## Montgomery Village Center Sketch Plan No. 320170020

### Description

Completed: 12/5/16

Figure 3: Proposed Site Plan

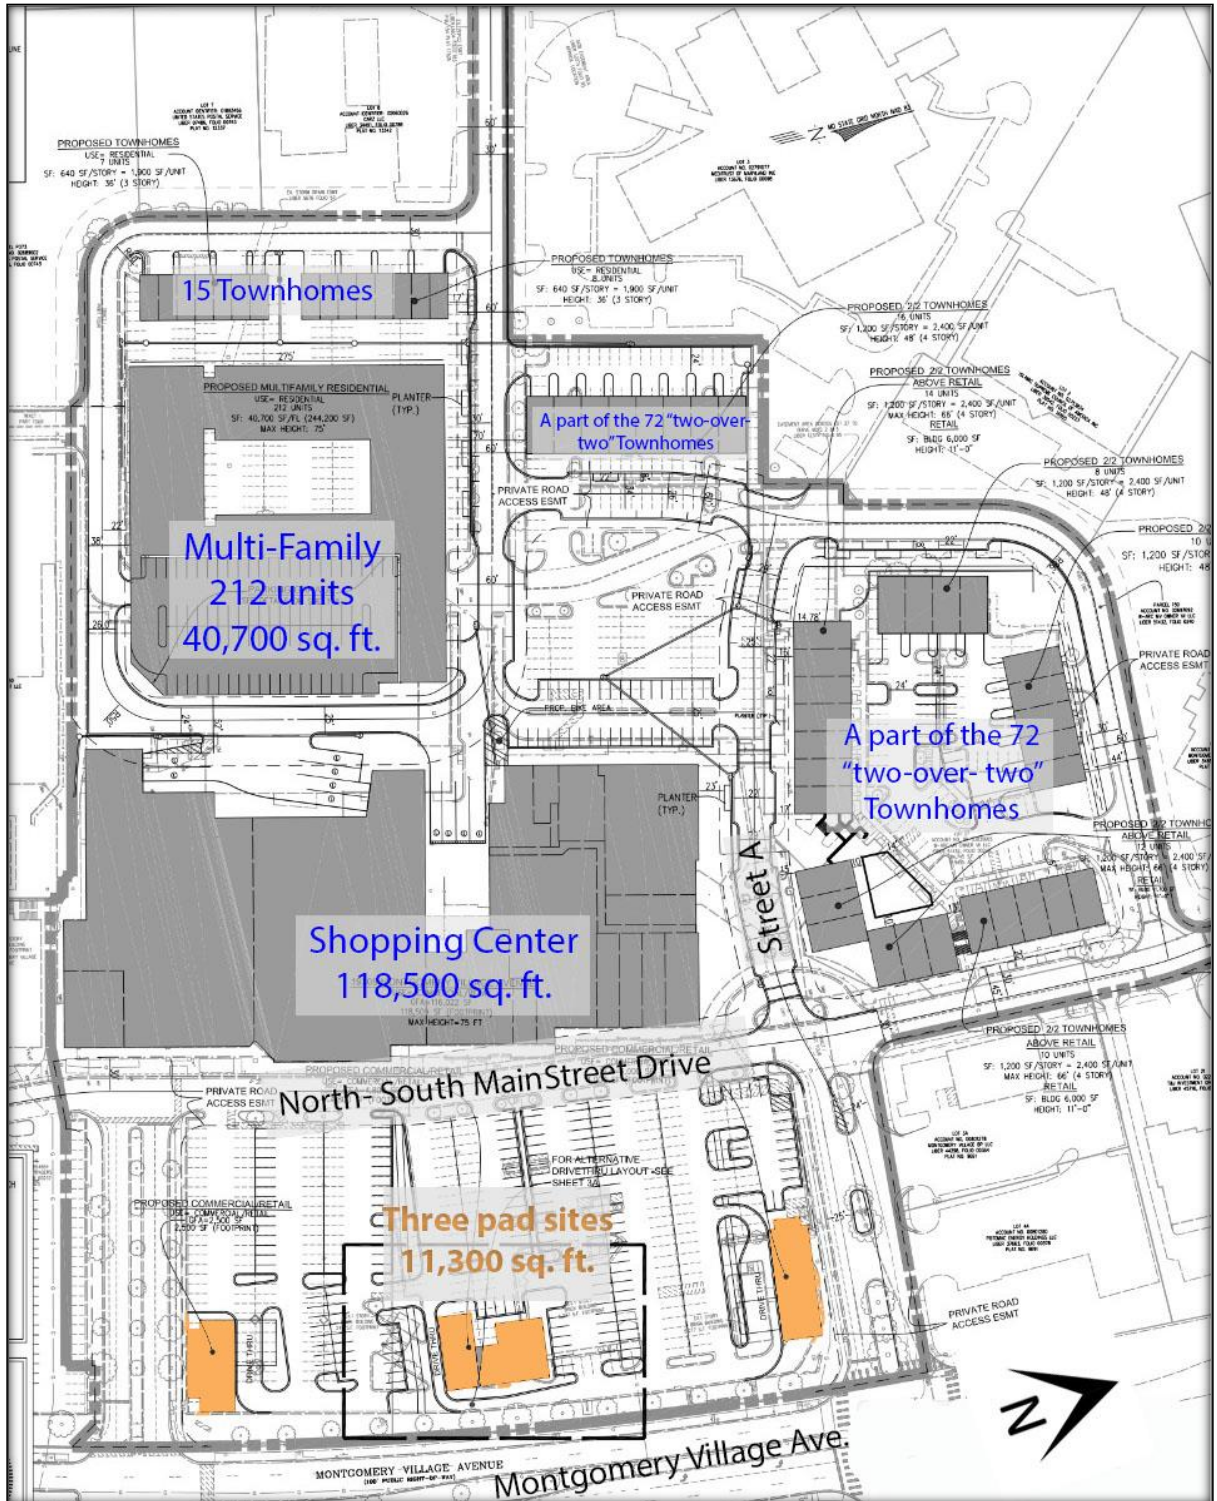
- a. On the northeast side of the multi-family building, the ground floor level units should be accessible from the street in order to activate the street edge.
- b. Reduce turning radii on all streets to the maximum extent allowed by the road code and approved by the Department of Permitting Services (DPS), Fire and Rescue.
- c. Provide a more consistent street tree canopy throughout the Site.

Figure 5: Conceptual rendering of Phase 2 open space (for illustrative purposes only)

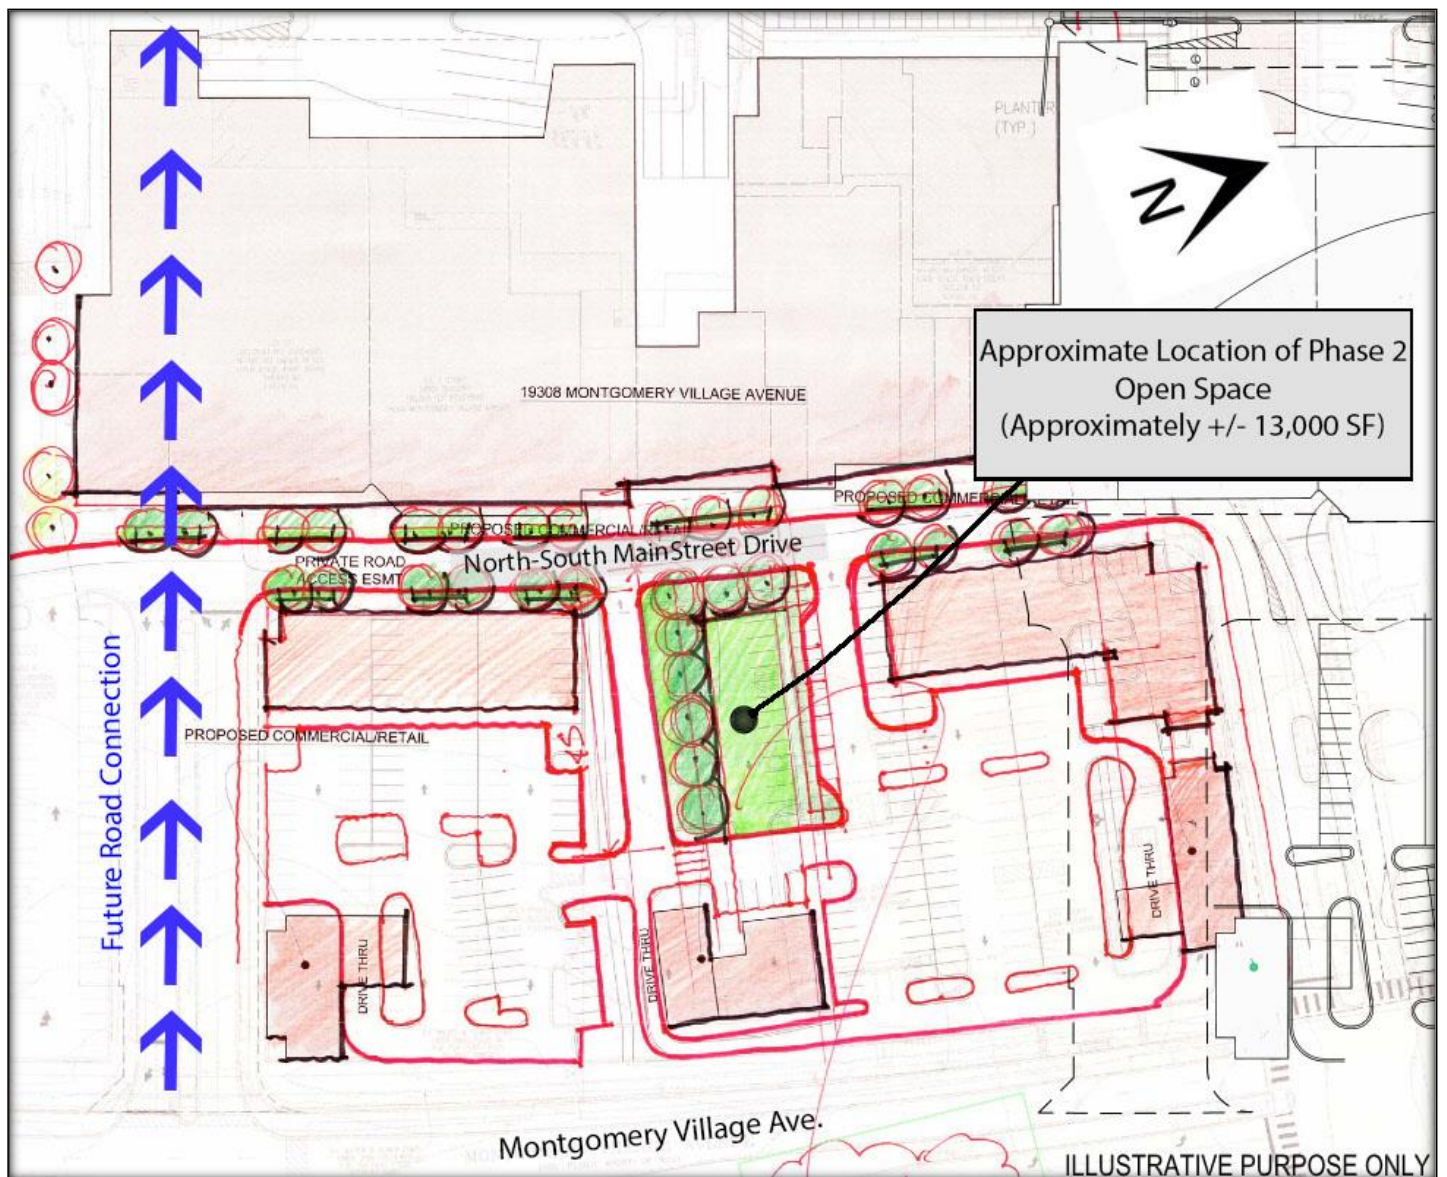
Phase 2 will also provide the remaining two percent of public open space, as shown in Figure 5 below. The location and size/configuration of the required public open space in Figure 5 is illustrative only to demonstrate the feasibility of accommodating the required public open space within the Phase 2 portion of the Site. It will be revisited at the time of redevelopment of Phase 2. At the time of sketch plan amendment for Phase 2, Staff recommends that the remaining public open space be located such that it connects to, and complements, the main square of the public open space in Phase 1. At the time of Phase 2 redevelopment, a vehicular and pedestrian connection must also be established between the existing north-south main street and the new road on the south side of the proposed multi-family building, shown as the blue arrows in Figure 5 below.

Figure 6: Alternative layout for conditional use scenario

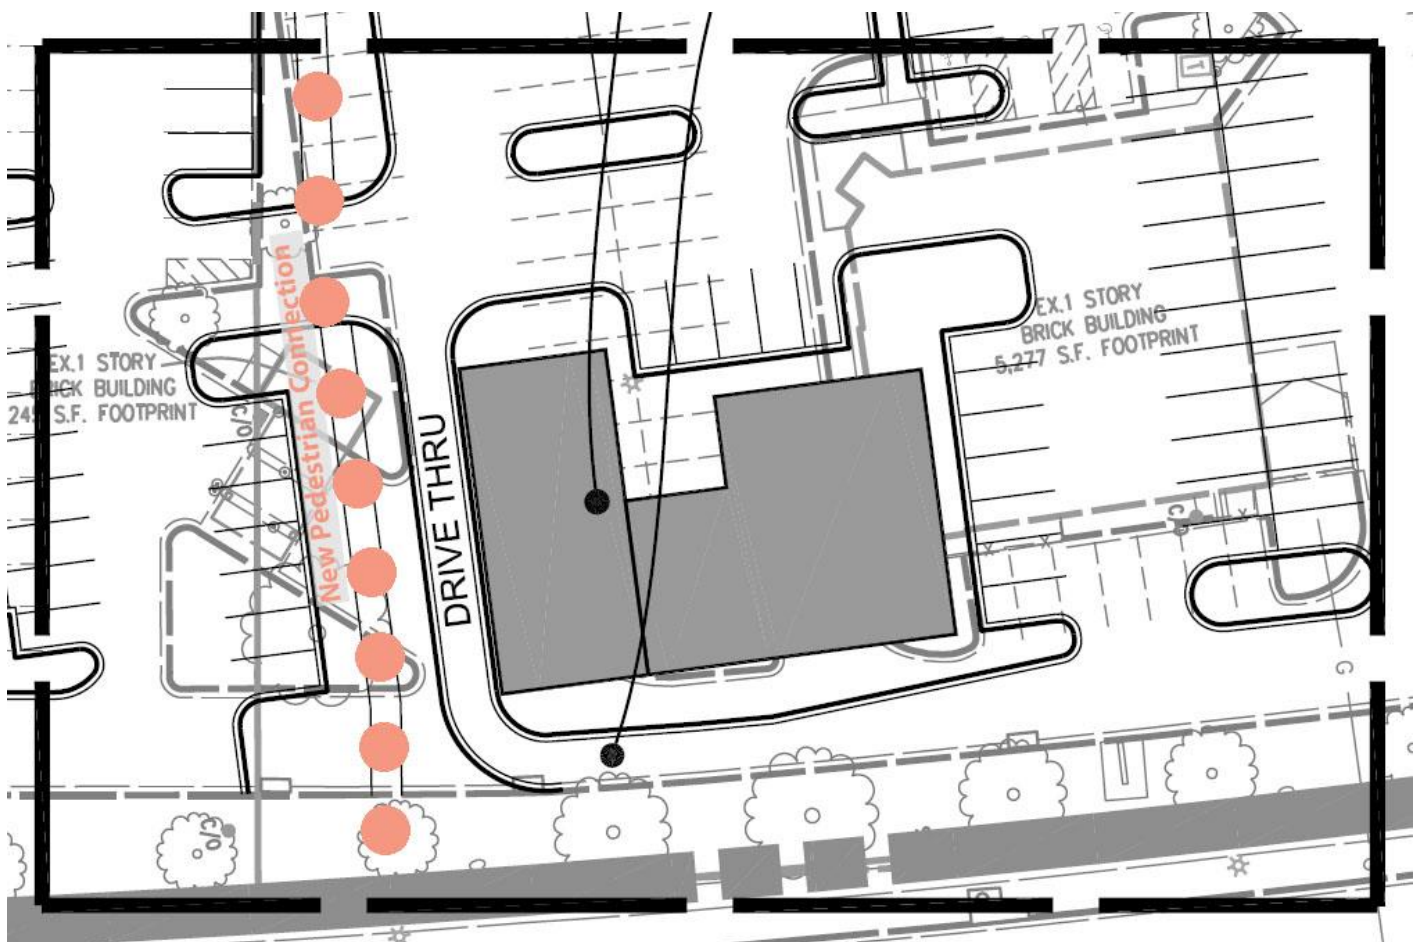
The proposal includes redevelopment of the existing pad sites along Montgomery Village Avenue. The Applicant has been able to address the Zoning prohibition in the CRT Zone on putting the drive-thru window or the drive aisle between the building and the street for two of the pad sites, but the third pad site in the center has a configuration that necessitates a drive-thru aisle between the building and the street in order to provide a direct pedestrian connection between the sidewalk along Montgomery Village Avenue and the new pathway in the redesigned parking lot (Figure 6 below). The zoning prohibition on a drive aisle between the building and the street can only be modified through a Conditional Use approval per Section 59-3.5.14.E.2.b. The Applicant intends to apply for a Conditional Use application to seek this relief and Staff supports this modification. The proposed Sketch Plan assumes that the Applicant will obtain this modification through the conditional use process. However, the Applicant has also included an alternative layout for this pad site that eliminates the drive aisle between the building and the street in case the Conditional Use is not granted. The Applicant must obtain this Conditional Use approval prior to filing the Site Plan for Phase 1.

Figure 8: Phase 1 public open space plan

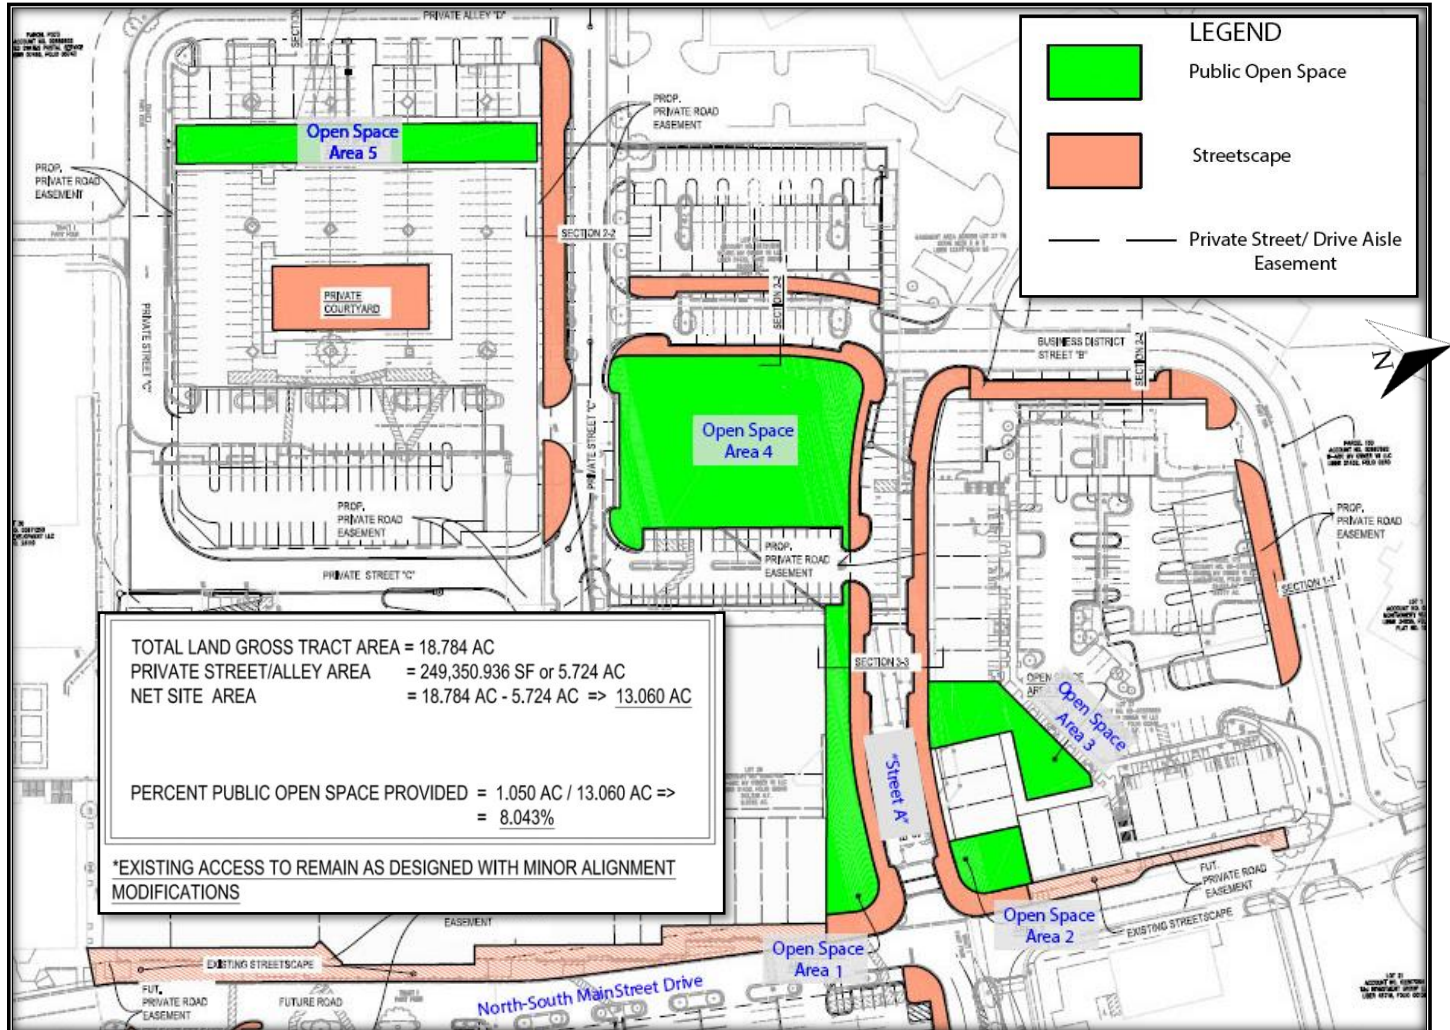
The required Public Open Space will be provided in two phases. In Phase 1, the total public open space provided is 8.04 percent, which is 11.8 percent of the net lot area for Phase 1. One of the recommended binding elements is that no stormwater management facilities be located in public open space areas. The Phase 1 Public Open Space consists of the following five distinct areas (Figure 8).

Area 3 is a split-level space that connects the midblock plaza area along Street A with the upper level green area surrounded by the new residential two-over-two townhomes. The final design of the stairs and overall space should be designed to be a destination with sitting areas and pockets of landscape rather than a pass through.

The required minimum 10 percent Public Open Space must be provided over two phases. The required Public Open Space must meet the standards of the optional method development per Section 6.3.6.B.2. and must not include any stormwater management facilities. It must be provided as illustrated in the Sketch Plan, and finalized at Site Plan for each phase.
